DA Stage BCA and Access Report

45 Orth Street, Kingswood

This report presents the findings of a DA Stage BCA and Access assessment of the proposed office building with ground floor retail/café and undercover carparking at 45 Orth Street, Kingswood. The development has been assessed against the relevant Deemed-to-Satisfy (DtS) provisions of Building Code of Australia (BCA) 2022.

Figure 2 – Barrier design development (removal of climbable elements)

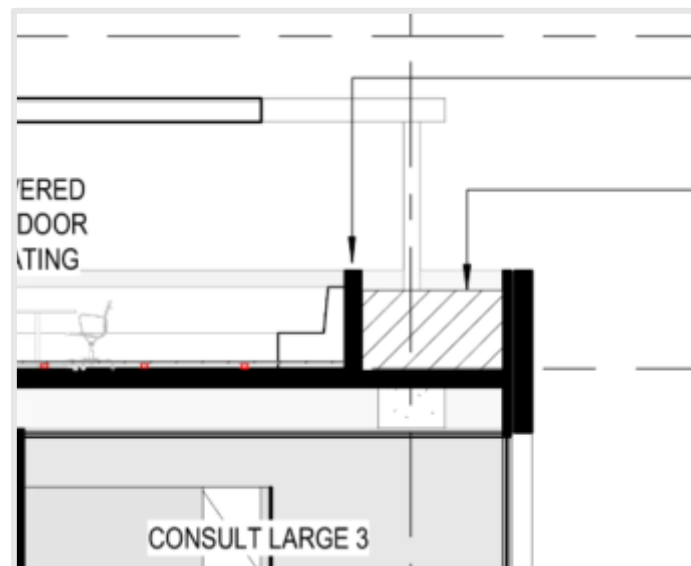
At CC stage, details of the stairway and all subsequent barriers (including the roof top terrace) will be required to confirm compliance with Clause D3D14 – D3D22. Throughout the roof top area, a minimum 1-metre-high barrier must be maintained above the floor level with no climbable elements located within 150-760mm of the barrier, therefore the attached seating must be removed from the barrier as this constitutes a climbable element.

Figure 3 – Reception turning spaces

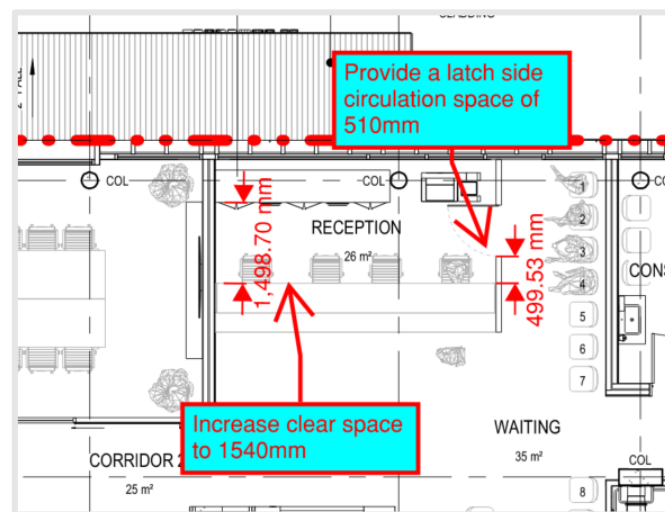
Access behind the reception area on Level 1 is required because it's not unreasonable for a person in a wheelchair to work as a receptionist, therefore a clear space of 1540mm must be provided between the desk and cabinets to allow space for a wheelchair to make a 180-degree turn. Furthermore, the doorway which provides access into the reception area must have a clear latch side circulation space of 510mm.
